Access Compliance Report

Public Rights-of-Way

(Curb Ramps)

| Intersection ID: 43133 | Main Street: STATESVILLE_AV | Cross Street: CARMINE_ST | Location: W |

| ADA ID: 9BB469FCC7BE | Ramp Type: ParaDiag | Initial Pass/Fail: Fail | Overall Compliance: No |

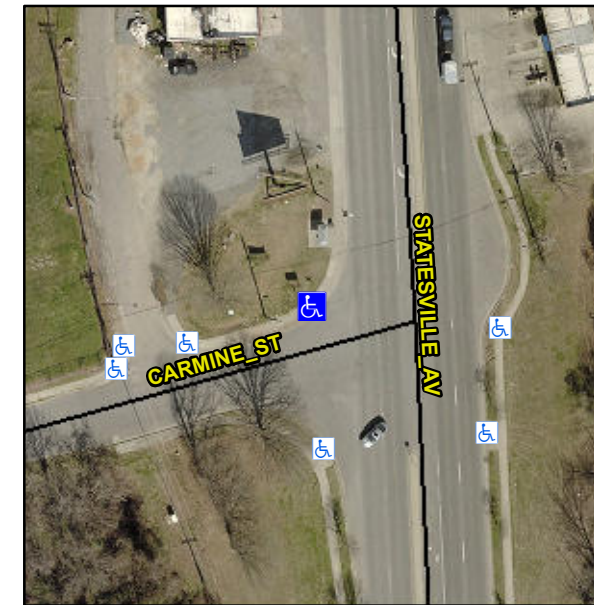
R304.5.3, R304.3.2

| Compliance | Description | Data | Compliance | Description | Data |
|------------|----------------------|-------|------------|-----------------------------|-------|
| Yes | Ramp Slope LT (%) | 7.4 | No | Ramp Slope RT (%) | 8.7 |
| No | Ramp XSlope LT (%) | 3.6 | Yes | Ramp XSlope RT (%) | 1.7 |

Remove & Replace Curb Ramp With Two New Directional Ramps or Equivalent.
